## STAFF REPORT

### Community Planning and Preservation Commission Certificate of Appropriateness Request

CITY FILE NO.: 20-90200115

Review of a Certificate of Appropriateness for the replacement of seven windows and the front door at 2728 2<sup>nd</sup> Ave N, a property proposed for inclusion as a contributing property to a local historic district currently pending public hearing – *Kenwood Section – Southwest Central Kenwood Local Historic District*.

Figure 1: Site plan showing the front door (65) and seven windows to be replaced.

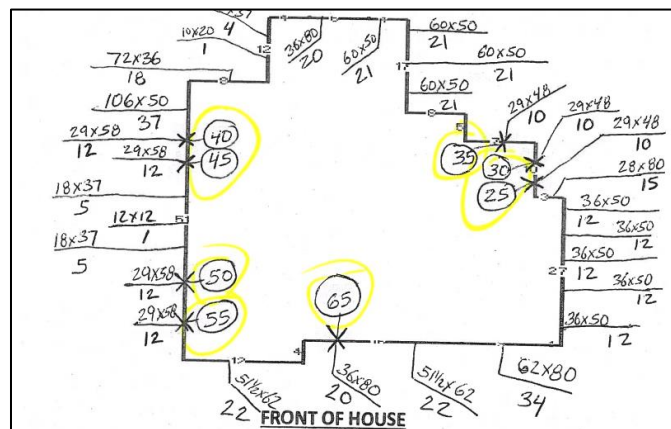
The application (Appendix A) proposes the removal and replacement of 7 historic windows and the front door. The windows that are proposed for removal are double-hung, wooden windows in a four-over-one configuration. The windows to be replaced are located on the side and rear elevations. The replacement windows are Pella fiberglass double-hung windows in a black finish that will include external, three-dimensional muntins to replicate the existing configuration. The proposed front door will be a Pella fiberglass door that is a traditional Craftsman-style door.

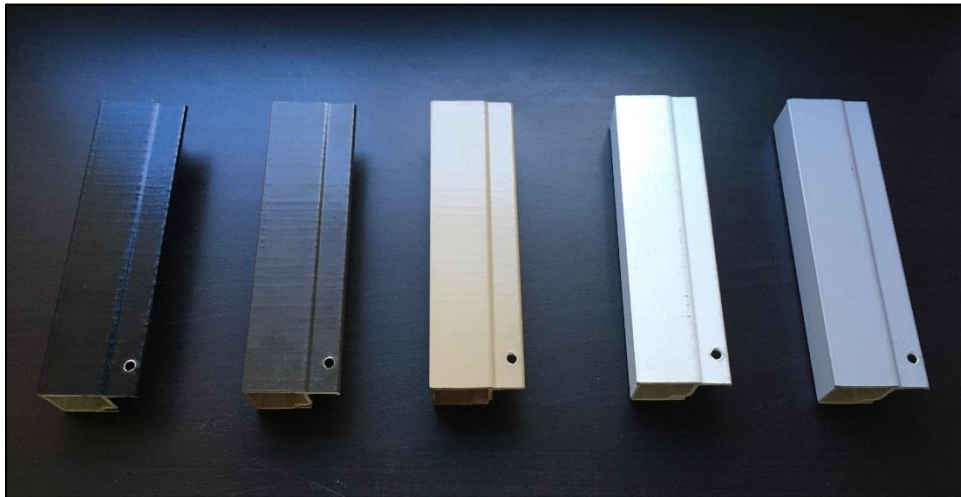
**Consistent** The configuration of the proposed windows will match the existing windows.

The window frames will be fiberglass. Staff has not seen a fiberglass window in person, but the applicant did provide some samples of fiberglass window material. The material has more of a matte finish with a bit of texture, attempting to give the window frame a closer appearance to painted wood, rather than the shiny, flat, and smooth appearance of vinyl.

1. Replacement windows will feature contoured, three-dimensional external muntins that replicate the existing configuration.
2. Windows will be installed to be setback within the wall plane and feature a reveal of at least two inches, to match existing window reveal.
3. Wooden exterior casing and trim will be reinstalled in kind.
4. The existing entryway opening and trim will be preserved, as proposed.
5. All other necessary permits shall be obtained. Any additional work shall be presented to staff for determination of the necessity of additional COA approval.
6. This approval will be valid for 24 months beginning on the date of revocation of the local Emergency Declaration.
